Reference: Creative Learning Centre - Access Report

Tender Documentation issue

CREATIVE LEARNING CENTRE SYDNEY OPERA HOUSE

Document Type: Access Report – Tender Documentation Issue

Figure 3 Creative Learning Centre - Egress Plan

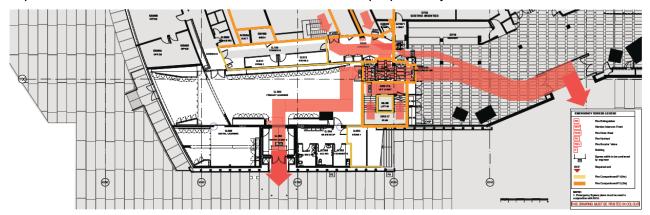
As part of these works the egress pathways have had to be modified. A new egress lobby is created at the base of Stair GRS17 and lift 9.

Braille tactile Exit signage associated with this door will need to be provided in accordance with the provisions of NCC Clause D3.6(a)(ii). The details of how this exit sign is to be integrated into the design will need to be identified as part of the detailed construction documentation.

Figure 4 Creative Learning Centre - Plan Drawing No 49 BR TZG07 Sheet A101 REV B

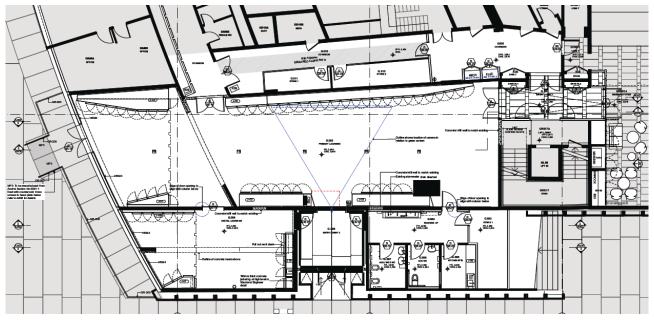
The main access related issues relate to the following:

- Accessible entry from the Western Concourse (Principle Pedestrian Entry)
- Accessible entry from the Western Foyer
- Provision of an accessible WC (Room G5.06)
- Provision of door assist devices to operate the doors where compliant latchside clearances are not able to be achieved. (Doors GR11, GR06 & GR13). Doors to be fitted with large format mushroom buttons to operate doors.
- Door GR12 to be held open when the Creative Learning Centre is in operation
- Wayfinding and signage
- Lighting levels

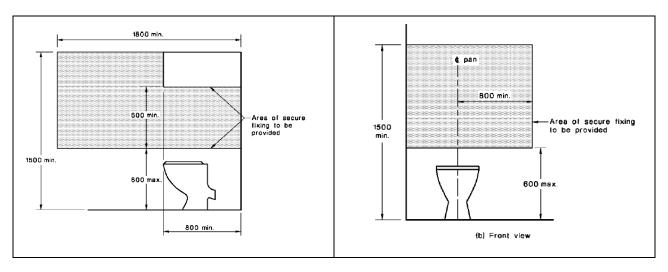
Visual indicators are required to be applied to glazing where the glazing could be mistaken as a doorway and where the handrail / guardrail is not installed against the glazing.

A design for the application of decals to the glazing will need to be developed to address this requirement.

The glare source of the external areas may possibly increase the need for the application of the decals.

Examples of visual indicators employed around the Opera House include:
